From: [Karen Thomas](#)
To: [Michele Schitko-Saboonchi](#)
Subject: RE: LUC60427692 - 1799A Great South Road, Drury s92 request
Date: Thursday, 30 May 2024 2:00:22 PM
Attachments: [image001.png](#)

SECTION 92 RESPONSE TABLE – VERNON DEVELOPMENTS LIMITED

This report is submitted to Auckland Council in response to the Section 92 request dated 8th February 2024. Please note that the responses below will supersede the AEE where relevant (i.e extent of earthworks within the ONF Overlay).

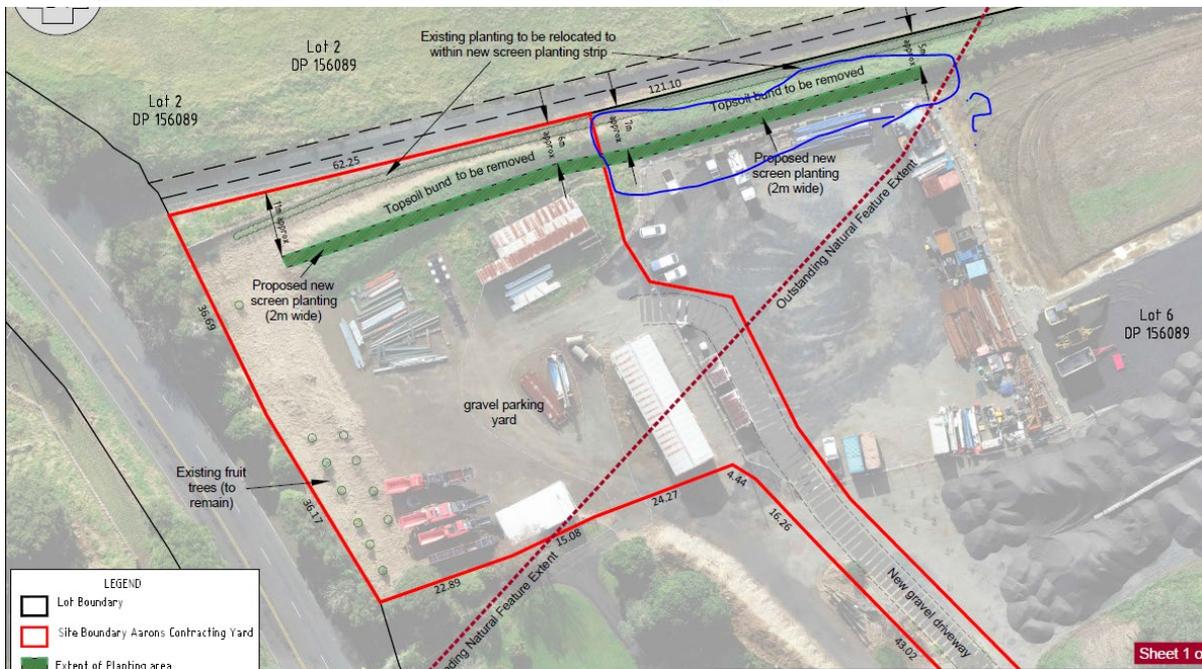
I just have one clarification needed about the planting marked with green stars on the planting plan – does this mean that the plants with green stars are only proposed in the NE half of the planting strip, circled in blue below?

PLANTS MARKED WITH * ARE TO BE RESTRICTED TO AREAS OF THE PLANTING ZONE OUTSIDE OF THE APPLICATION AREA DENOTED BY THE RED BOUNDARY (SITE BOUNDARY OF AARONS CONTRACTING YARD)

THE EXISTING PLANTING ON THE TOPSOIL BUND (TO BE REMOVED), IS TO BE RELOCATED TO THE NEW PLANTING STRIP POSITION SHOWN ON THIS PLAN. ANY ADDITIONAL PLANTING WILL BE SELECTED FROM THE ABOVE LIST

PLANTING IS TO BE MIXED IN APPROXIMATELY EVEN RATIOS TO PROVIDE A NATURAL AESTHETIC WITHIN THE 2m WIDE PLANTING ZONE SHOWN

SHEET 3 OF 3

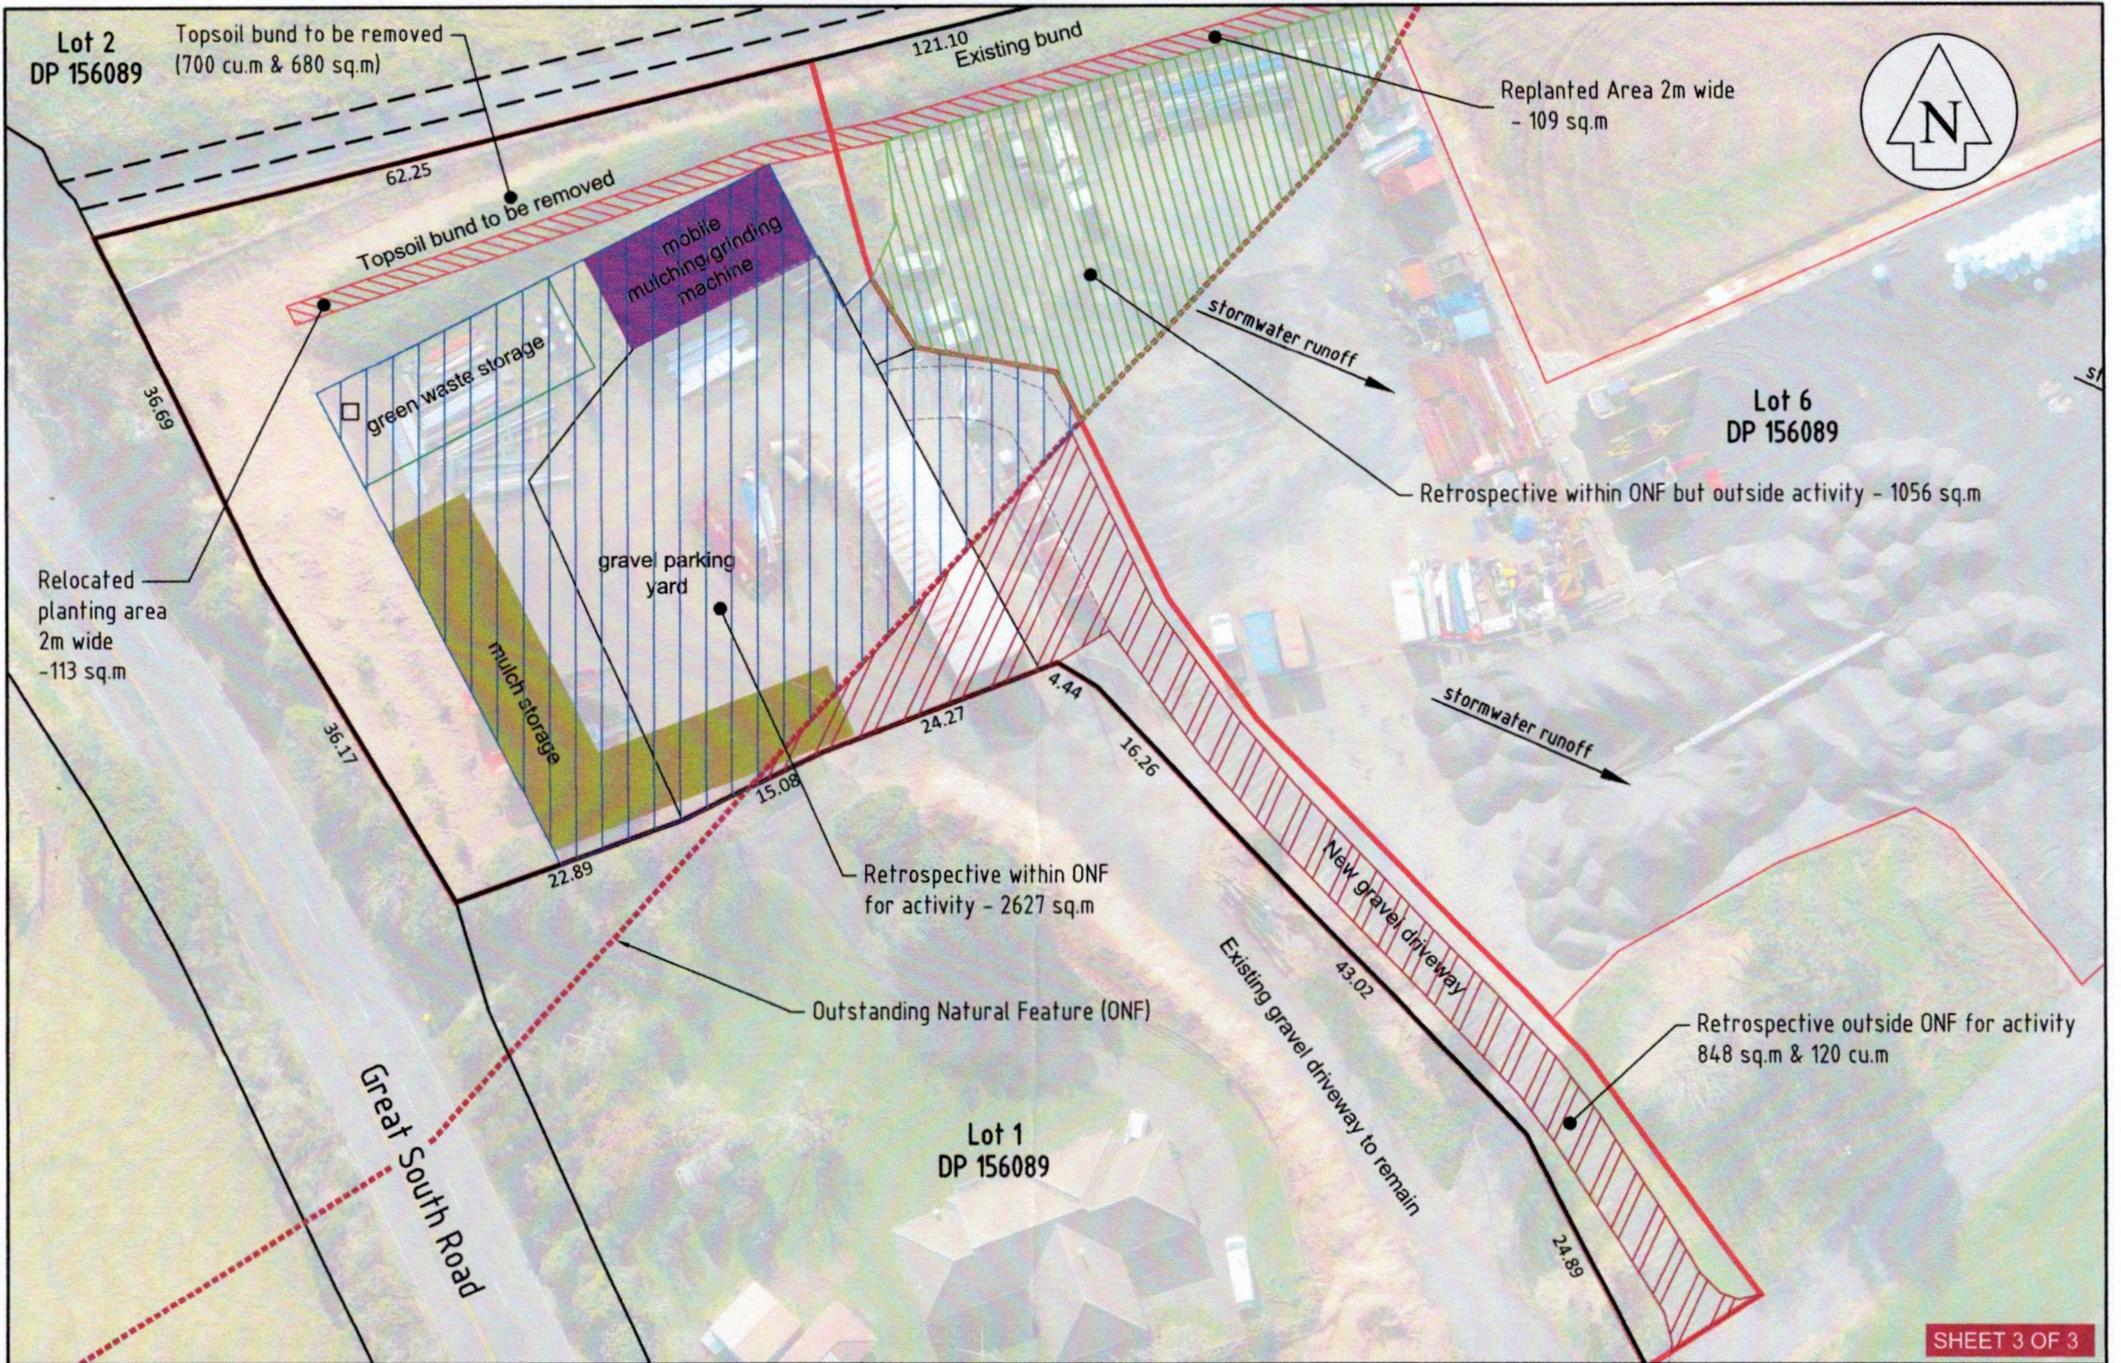
2. Please show the location of the relocated earth bund on the application plans.

Please see enclosed updated site plan showing the location of the relocated earth bund adjacent to the southern boundary of the site.
